Monday, 24th April, 2023 - 2.00 p.m.

AGENDA

3. **MINUTE** – Minute of meeting of the Fife Planning Review Body of 13th February, 2023. 5 - 7
4. **APPLICATION FOR REVIEW - 14 MORTIMER COURT, DALGETY BAY (APPLICATION NO. 21/02523/FULL)** – Alterations to existing rear extension including installation of roof lantern.

Application for review of refusal on planning application 21/02523/FULL

Stage:		
PLANNING		
Project:		
14 MORTIMER COURT		
Client:		
CATH CHORLEY		
Project Address:		
14 MORTIMER COURT DALGETY BAY, KY11 9UQ		
Title:		
SIDE ELEVATIONS AS EXISTING /AS PROPOSED		
Drawn by:	Checked by:	Project no:
KK	AN	
Date:		2101
23/08/2021		
Scale:	Drawing no:	Rev:
1:50 (A2)	A106	A

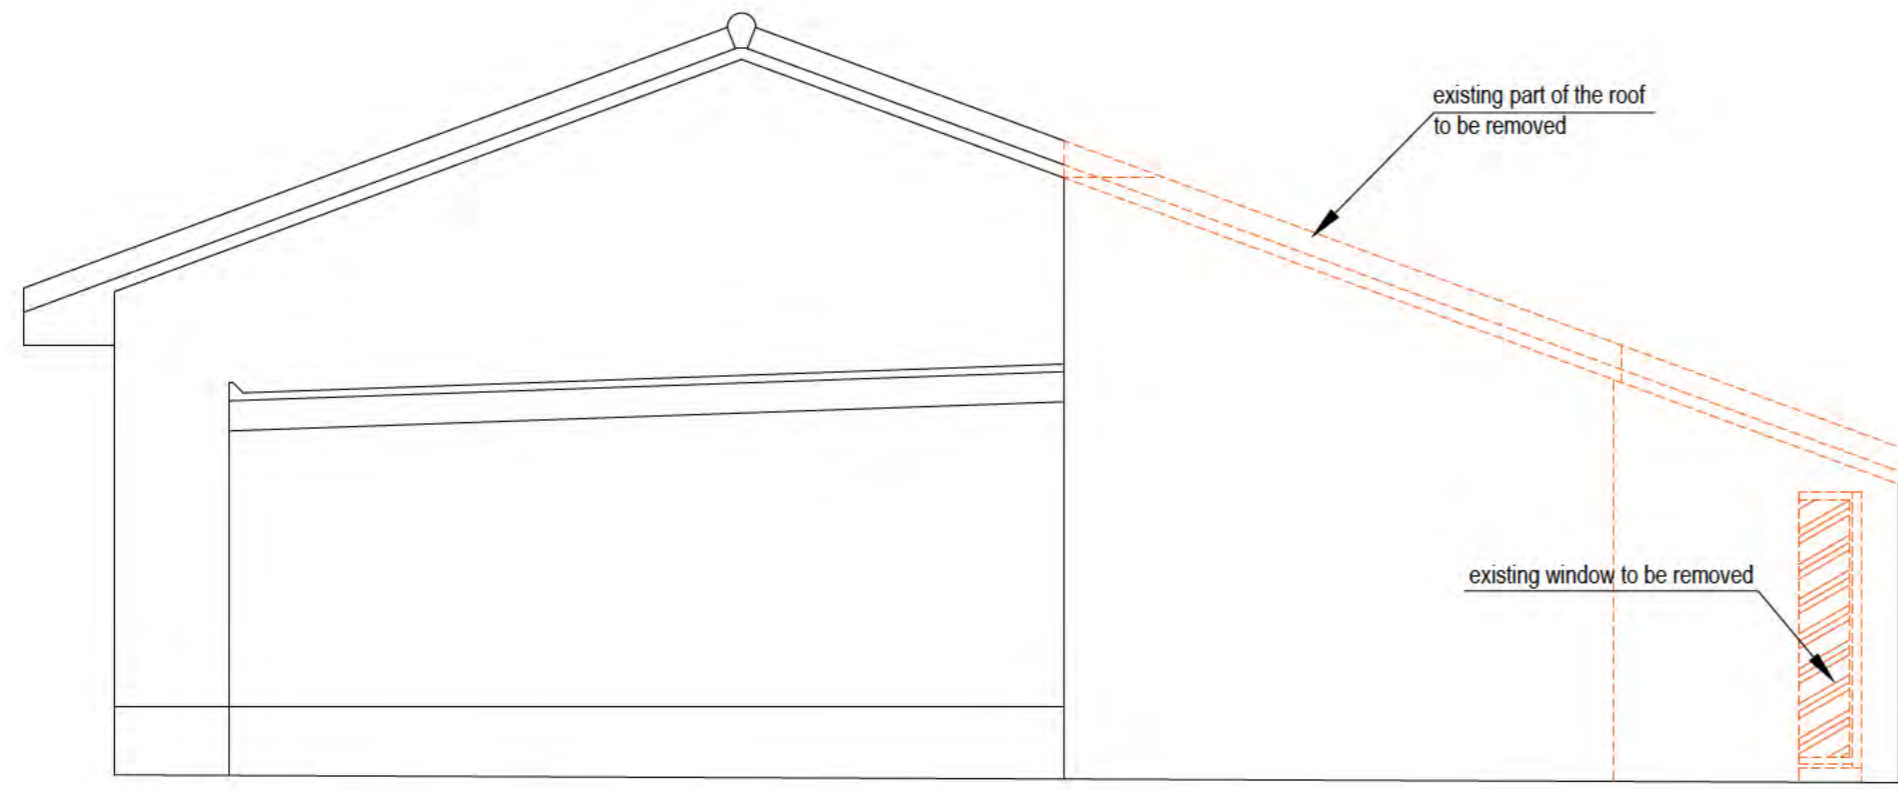
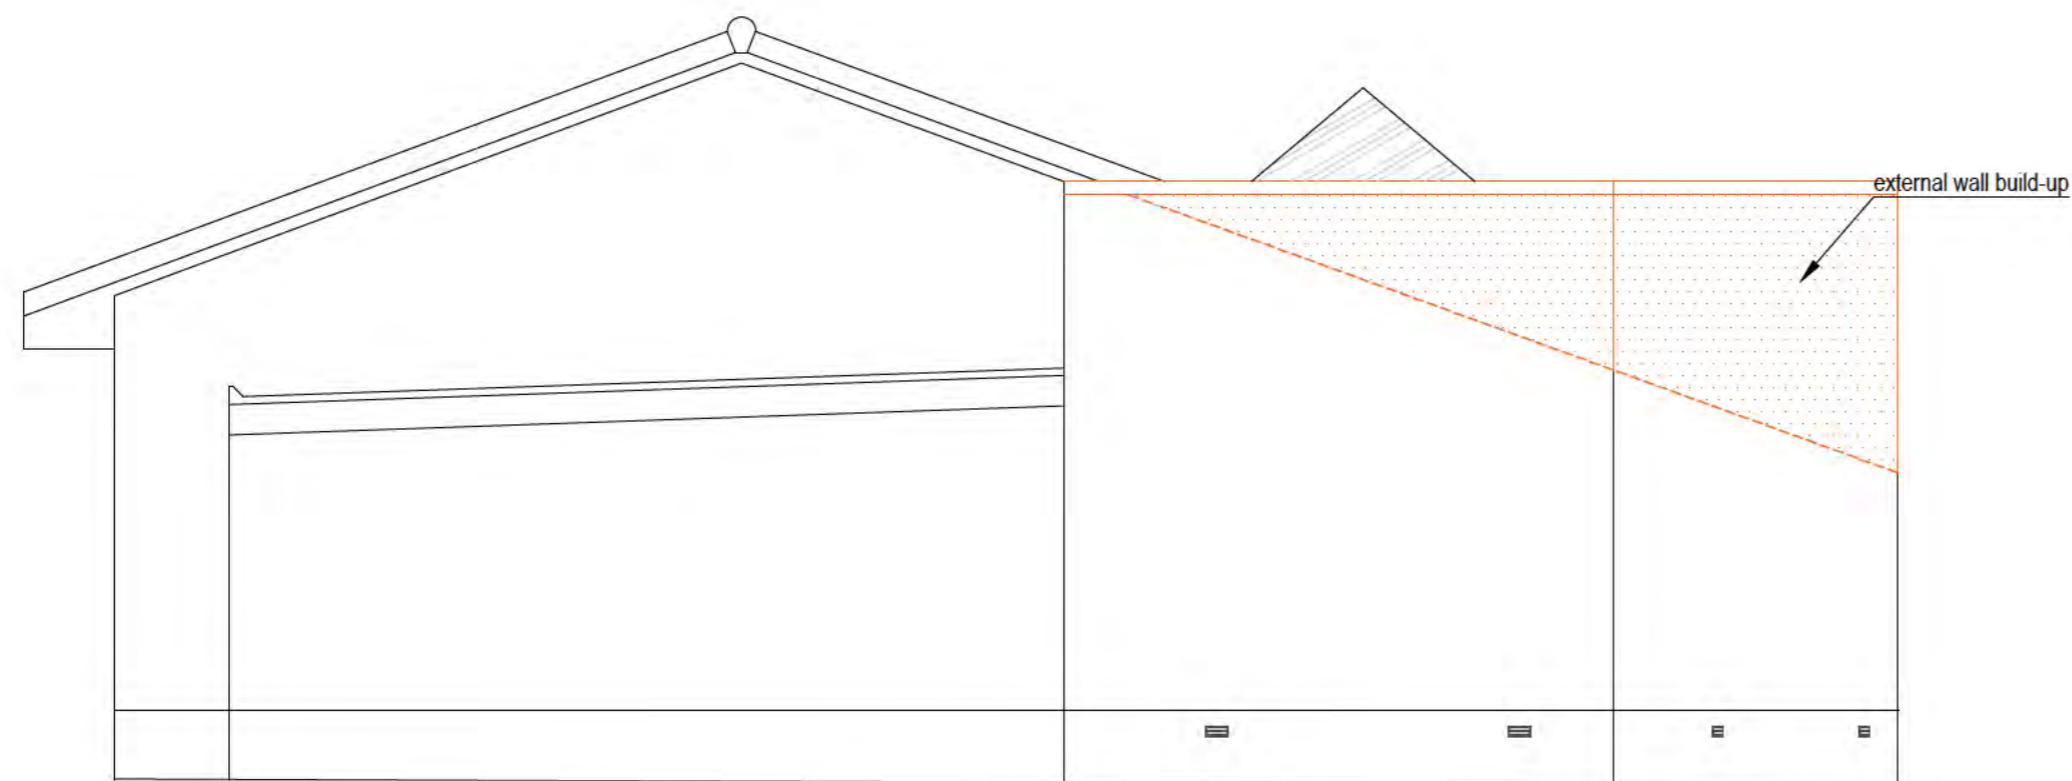
The before and after drawings also show how minimal the change actually is.

- The situation for the neighbours has been improved as an existing window looking directly into the neighbour's house has been removed and replaced with the rooflight. **As per the 26/7/21 email from planning the alterations would be permitted development except for the fact that this glass rooflight projects slightly above the 4m height.**
- The original design aesthetic of the estate is to have pitched roof houses with flat roofed ancillary buildings. In changing to a flat roof (for disabled access) the applicant is following the original design aesthetic of the estate. This is particularly relevant as the altered roof is immediately behind the flat roofed garage.

Stage:	PLANNING	
Project:	14 MORTIMER COURT	
Client:	CATH CHORLEY	
Project Address:	14 MORTIMER COURT DALGETY BAY, KY11 8UQ	
Title:	ELEVATIONS AS PROPOSED	
Drawn by:	Checked by:	Project no:
KK	AN	
Date:	29/05/2021	2101
Scale:	Drawing no	Rev.
1:50 (A3)	A103

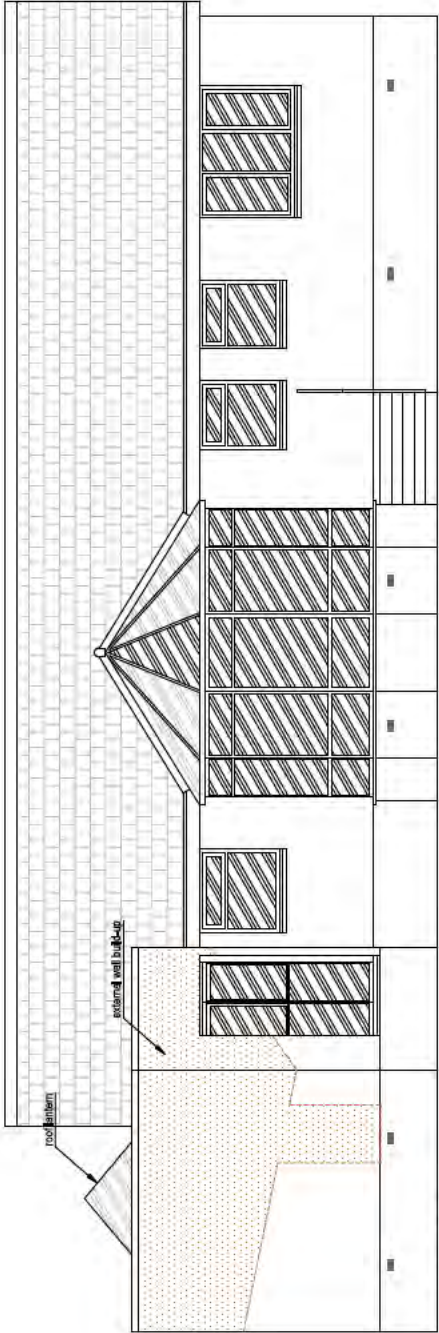
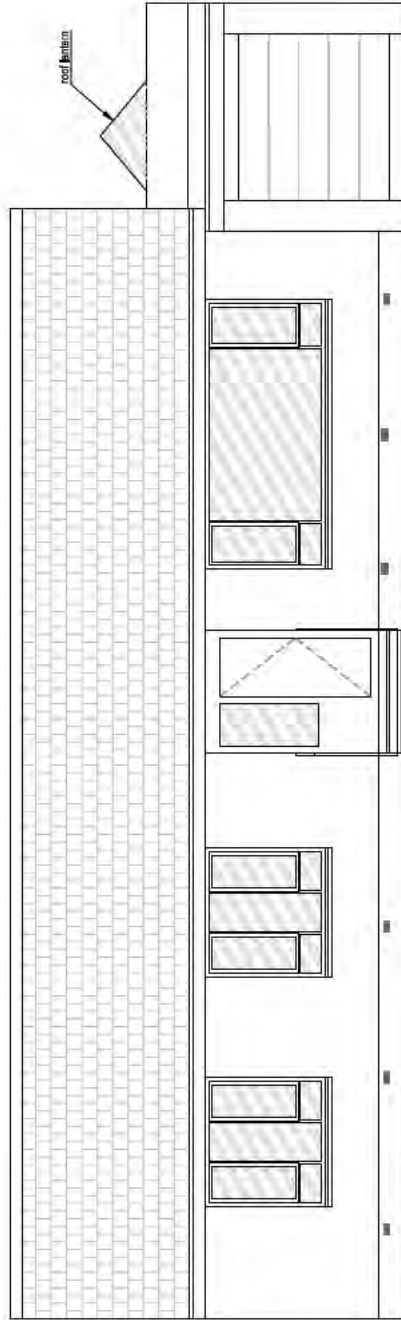
1. The "Elevation as existing" and "Elevation as proposed" drawings in the planning portal would appear to indicate that the alterations have lowered the extension. This is not the case as the extension is notably higher as well as losing the sloping roof line now replaced by a square roofline. Obviously the original structure is no longer visible due to the work having already been carried out and the available "before" photographs in the portal not making this apparent. However on the attached photographs 1,2 and 3 the original rendering can be seen showing the original size and sloping roofline of the extension.

I have spent time appraising the application by comparing it to the work carried out, and I feel compelled to point out that the work carried out is at variance to scale drawings A103 and A106 (copies attached). Measured accurately on the scale drawings the height from the garage roof to the new flat roof is 0.5 metres. However, during construction the builder has added three more courses of breeze block which adds another 0.5 metres to the height and, as a consequence, the height of the rear wall is now 4.4 metres instead of 3.9. The effect is that the extension is higher than planned. I have attached photographs and request you view them to compare the work done against the the scaled drawings. In summery, scale drawing A106 shows the new flat roof should be positioned at mid height between the garage roof and the building eaves, but photographs 14MC1 and 14MC2 show the flat roof has been built right up to the eaves - i.e. an additional three courses of breeze block. Surely the builder would not have done that if he was working to the drawings in this planning application. However, since drawing A106 revision D is dated 23/08/2021, he probably didn't have a copy!.

Stage:	PLANNING	
Project:	14 MORTIMER COURT	
Client:	CATH CHORLEY	
Project Address:	14 MORTIMER COURT DALGETY BAY, KY11 8UQ	
Title:	SIDE ELEVATIONS AS EXISTING /AS PROPOSED	
Drawn by:	Checked by:	Project no:
KK	AN	
Date:	23/05/2021	2101
Scale:	Drawing no:	Rev:
1:50 (A3)	A106	D

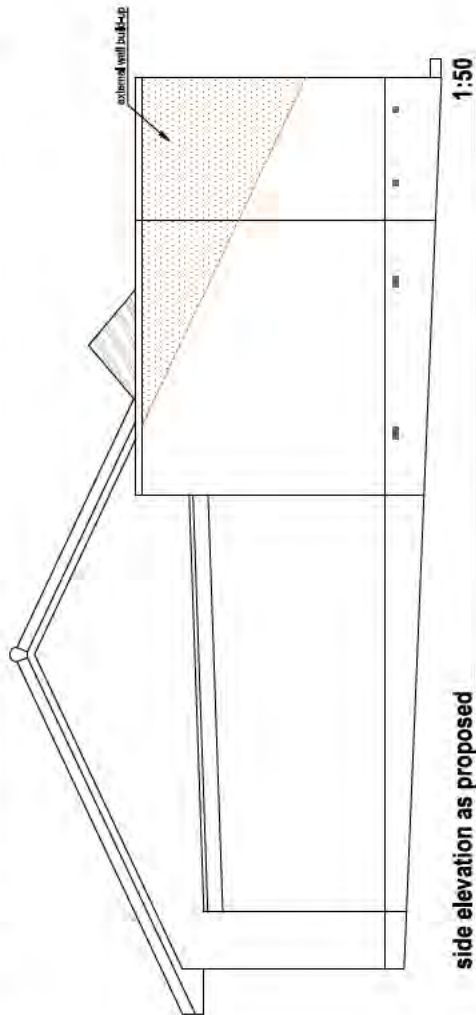
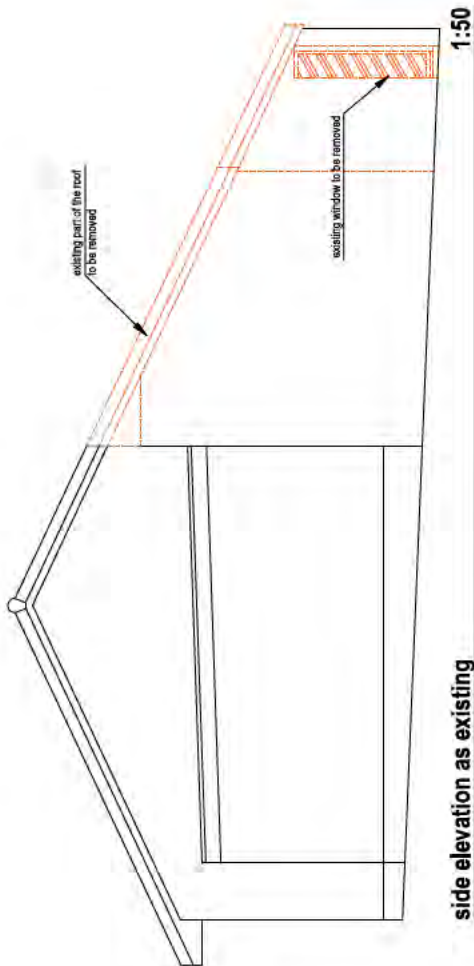
The Architect submits drawing A106, dated 23/08/2021, revision A , which shows the wall should be built to a height of 3.9 metres (see IMG 0106). Instead the wall is built to a height of 4.4 metres. So drawing A106, revision A, isn't representative of what's been built. At the time of the initial application drawing A106 was revision D, which also gave the wall height as 3.9 metres. In my initial objection I asked how a Completion Certificate could be issued if the extension isn't built in accordance with the drawings. So, there's no change here.

Before

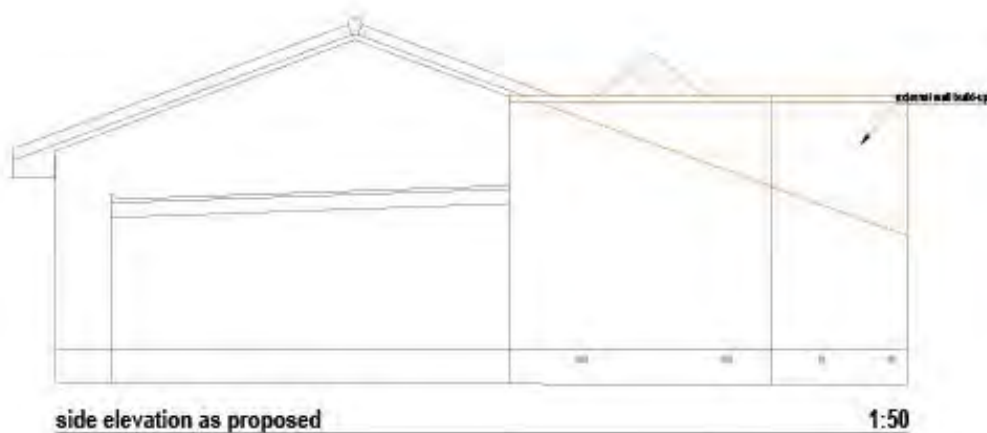
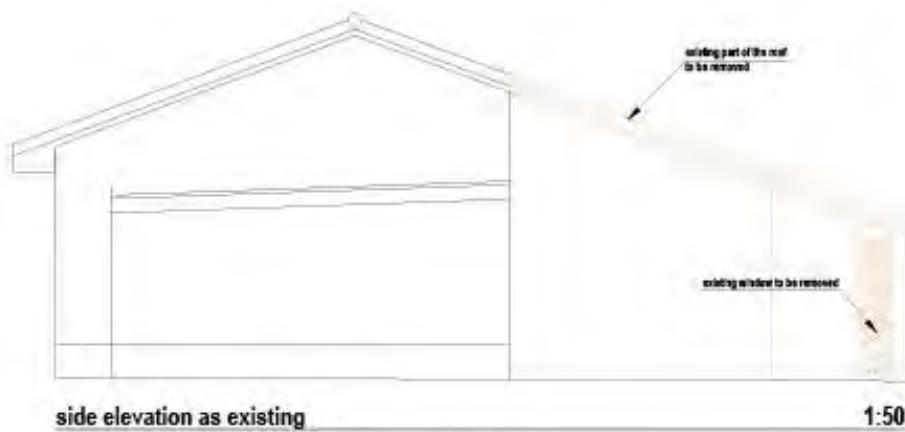
Applicant Response: We believe the statement *“In this regard, the proposal is considered to create a visually dominant addition from various interfaces”* is at the very least misleading .

- Even looking obliquely from the front street the new roofline is unobtrusive. Here’s a photograph from this angle. Whilst it can be also be seen looking across two back gardens from the road around the corner this is not the principal elevation and is across back gardens.
